UNITED STATES OF AMERICA
NUCLEAR REGULATORY COMMISSION

License Amendment Request
No. 86-03

TECHNICAL SPECIFICATIONS 3.6.2.3 AND 3.6.1.4
AND BASES 3/4.6.1.4 AND 3/4.6.1.6

CONTAINMENT INTERNAL PRESSURE AND FAN COOLER OPERABILITY
TECHNICAL SPECIFICATION CHANGES

FIGURE 1. LOCA Pressure Transient
With 80 Second Spray Pump Delay

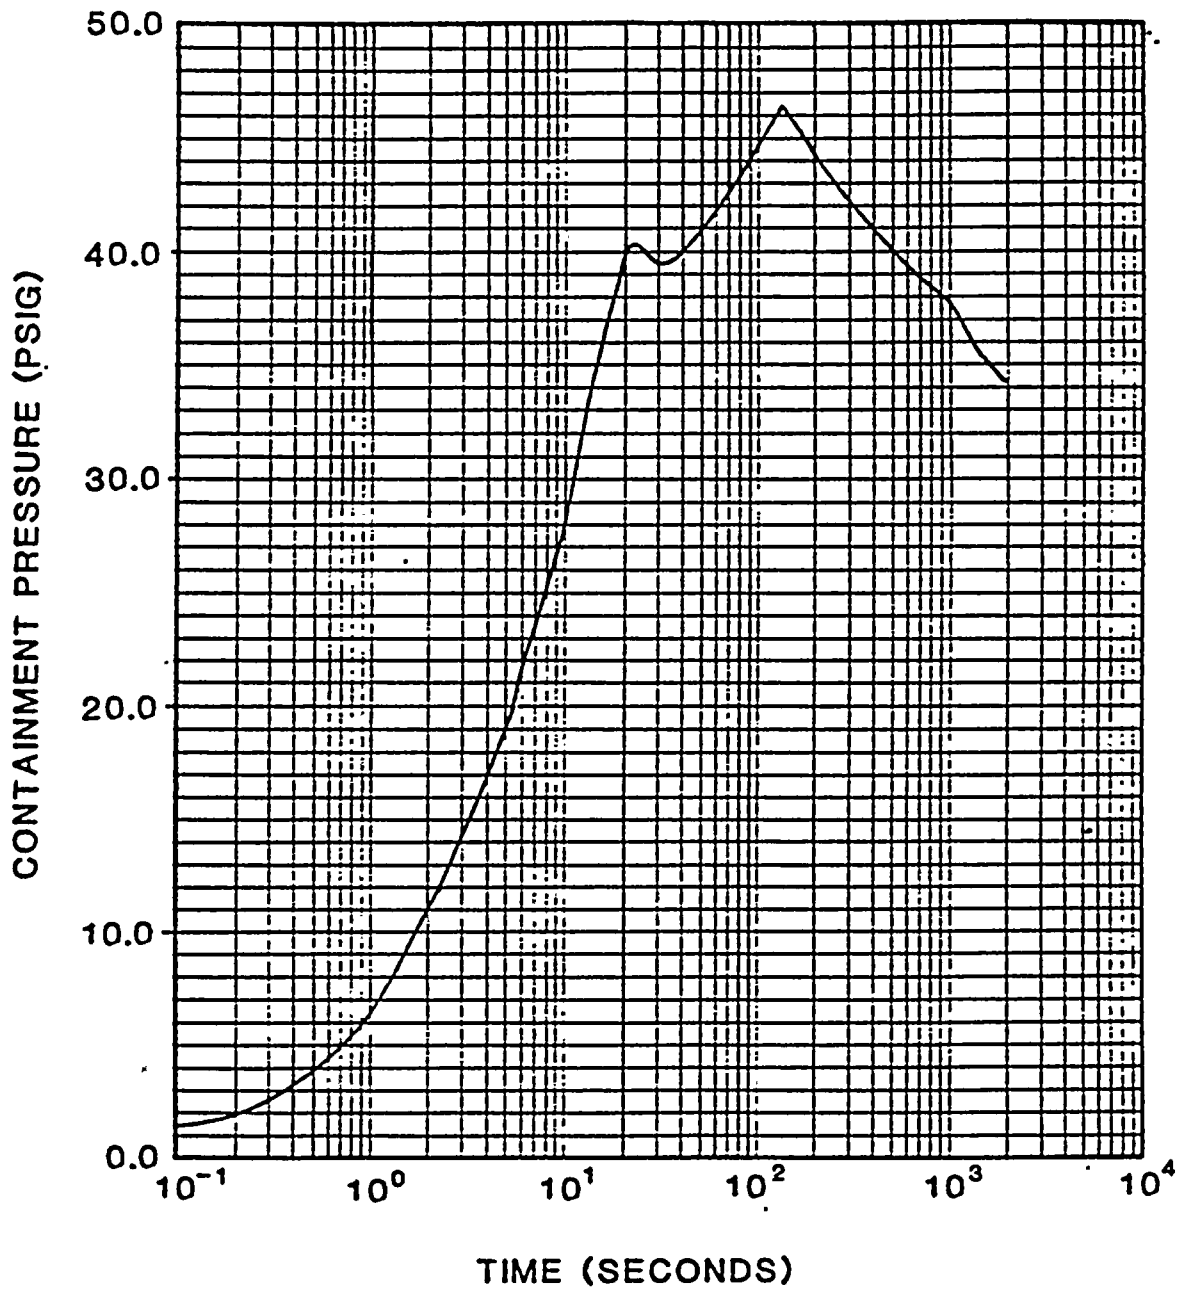
The results of the revised double-ended pump suction break case show a peak containment pressure of 46.65 psig for an 80 second spray pump delay time after the high-high containment pressure setpoint is reached. This is below the containment design pressure of 47 psig. The containment pressure and temperature transients are shown in Figures 1 and 2. Therefore, maximum positive containment internal pressure specified in Technical Specification 3.6.1.4 can be changed from +0.3 psig to +1.2 psig. Also, Technical Specification 3.6.2.3 can be revised to assure two containment fan cooler units are available assuming a single active failure.

NOTE: (1) This figure replaces information provided in Figures 6.2B-1 through 6.2B-8 of the DCPD FSAR Update (Revision 2, September 20, 1985).

FIGURE 2. LOCA Temperature Transient
With 80 Second Spray Pump Delay

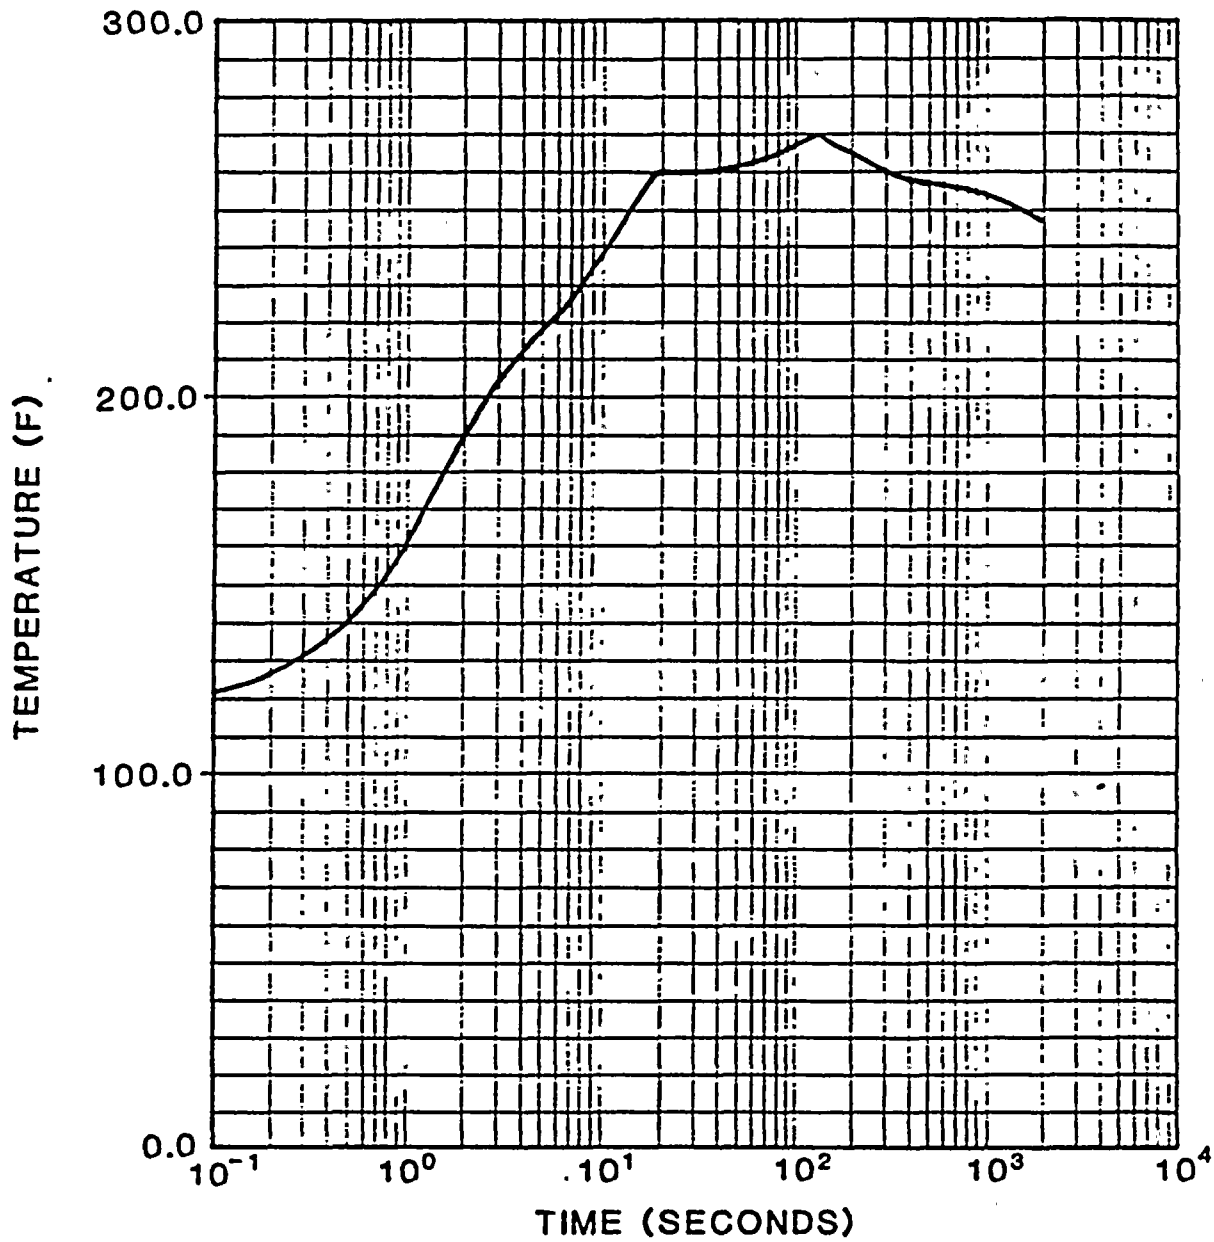
NOTE: (1) This figure replaces information provided in Figures 6.2B-1 through 6.2B-8 of the DCCP FSAR Update (Revision 2, September 20, 1985).
